TO: Mercedes-Benz Dealer Principals, General Managers, Sales Managers, Service Managers, Parts Managers	FROM: Gregory Gunther, Senior Manager, Vehicle Compliance and Analysis, Engineering Services
RE: Recall Campaign Launch Notification Check the 12V Ground Connection Bolt Torque MY21-22 GLE (167 platform)	DATE: January 12, 2024

Campaign No. 2023120010, December 2023

SUBJECT: **Model GLE (167 platform)**
Model Year 2021-2022

Check the 12V Ground Connection Bolt Torque

Figure 1

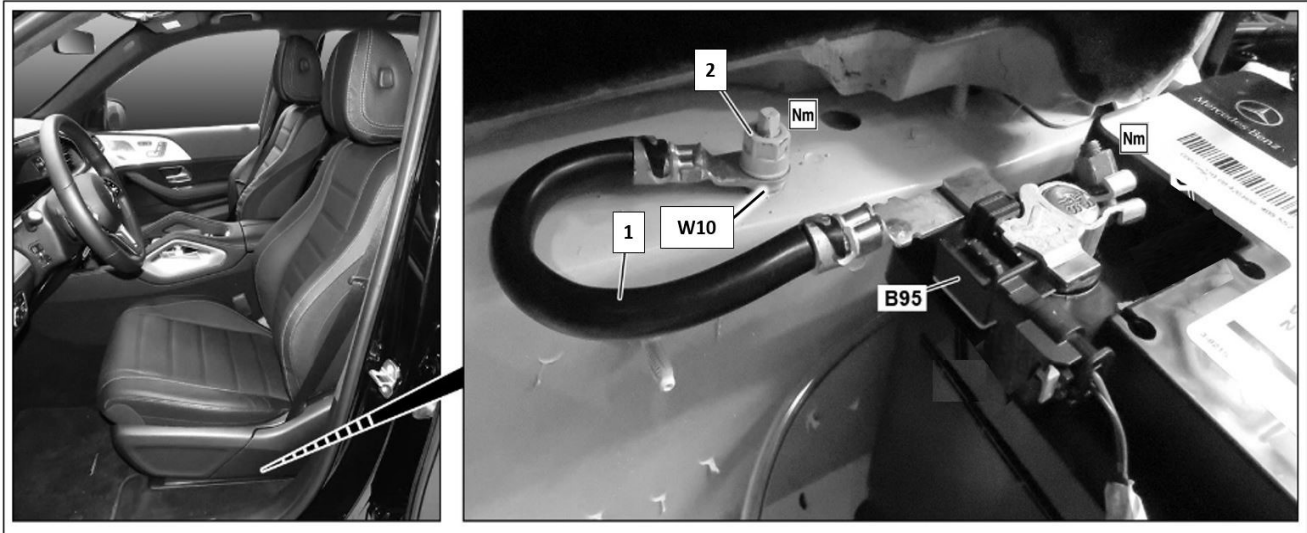
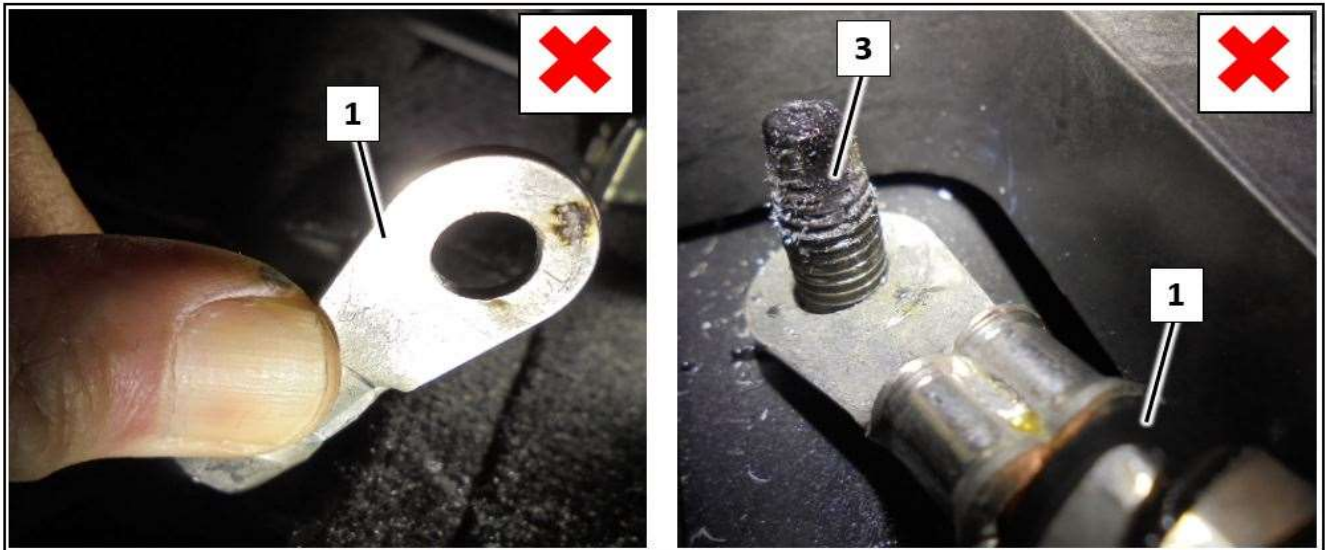
1. Visually check ground point (W10, Figure 1) and ground line (1, Figure 1) under the driver's seat for damage.
 - i** For basic information, see AR54.10-P-0002ME.

- a. If **no damage** is present:
Carry out Check/test Procedure 2.
- b. If **there is damage** to the ground line (1, Figure 1) or ground point (W10, Figure 1):
Carry out Work Procedure 2.

2. Check nut (2, Figure 1) for correct tightening torque.
 - i** For basic information, see AR54.10-P-0002ME.
 - a. If tightening torque of nut (2, Figure 1) is correct and no damage present:
End measure.
 - b. If tightening torque of nut (2, Figure 1) **is not correct**:
Carry out Check/test Procedure 3.

5. Install existing ground line (1, Figure 1) including battery sensor (B95, Figure 1) with **new** nut (2, Figure 1) and tighten with prescribed tightening torque.
i For basic information, see AR54.10-P-0002ME.

6. **Clean** area around ground point (W10, Figure 1) and threaded pin.
i If necessary, recut threaded pin using a thread cutter.
7. **Replace** ground line (1, Figure 1) including battery sensor (B95, Figure 1) and nut (2, Figure 1).
i For basic information, see AR54.10-P-0002ME.
8. Perform commissioning of battery sensor (B95).
i For basic information, see AD00.00-P-2000-06ME.
